TAYLOR DEEP 12 FEDERAL 1Y

**Taylor Deep 12 Federal 1Y
2235' FSL & 2235' FWL Sec 12 - 18S - 31E
Eddy County, NM
API: 30-015-25759**

**Permanent Abandonment of Federal Wells
Conditions of Approval (LPC Habitat)**

See attached WBD & Proposed WBD

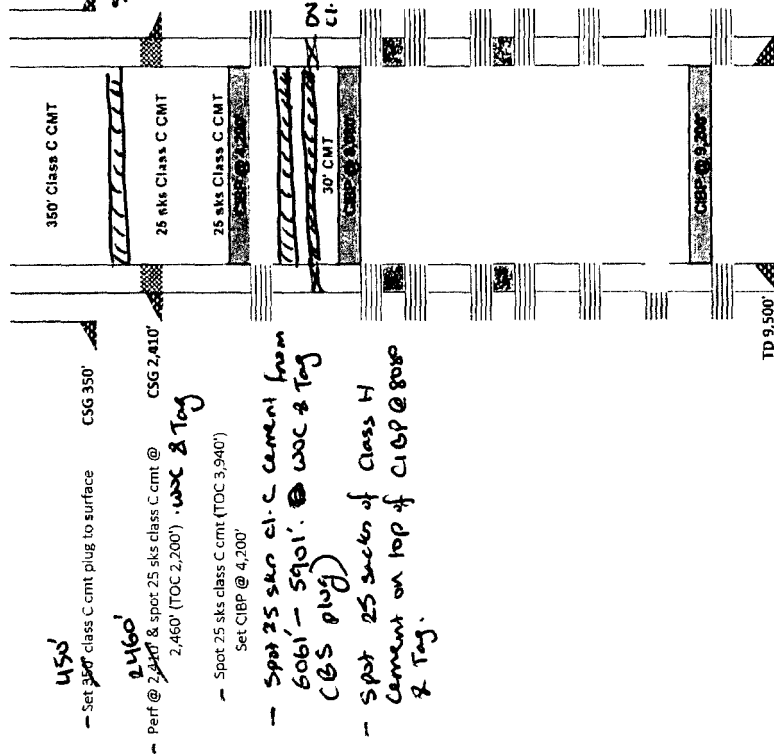
* Top of CIBP @ 8080' needs to be tagged to verify depth. Spot 25 sacks of CI. H cement on top 2 Tag.

* DN tool @ 6462'. Spot 25 sacks Class C cement

from 6512' - 6552' - woc 2 Tag

* Spot 25 sacks class C cement from 6061' - 5901'.

woc 2 Tag (BS plug)
